E8363C-02A

S E R V I C E N O T E

E8363C PNA Microwave Network Analyzers

A new touchscreen display inverter shield is available to improve PNA noise floor performance.

Figure 3

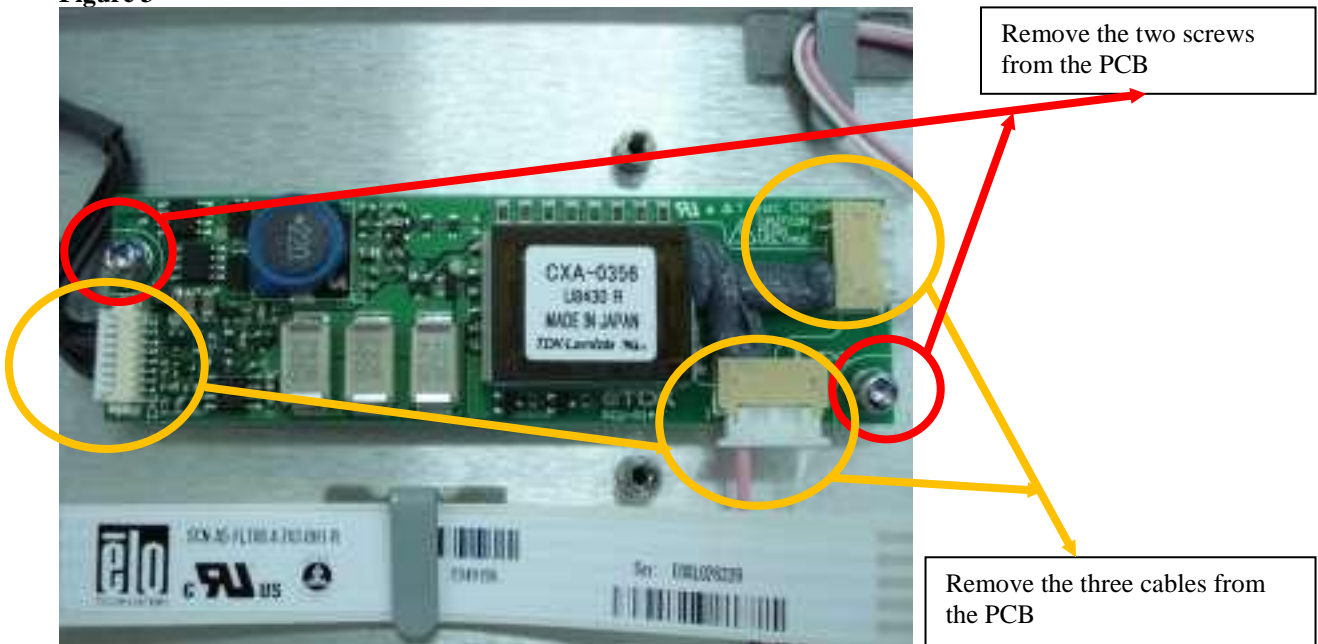
10. Remove the two screws from the PCB shown in Figure 3, using a T-10 wrench.
Disconnect the three cables connected to the PCB.
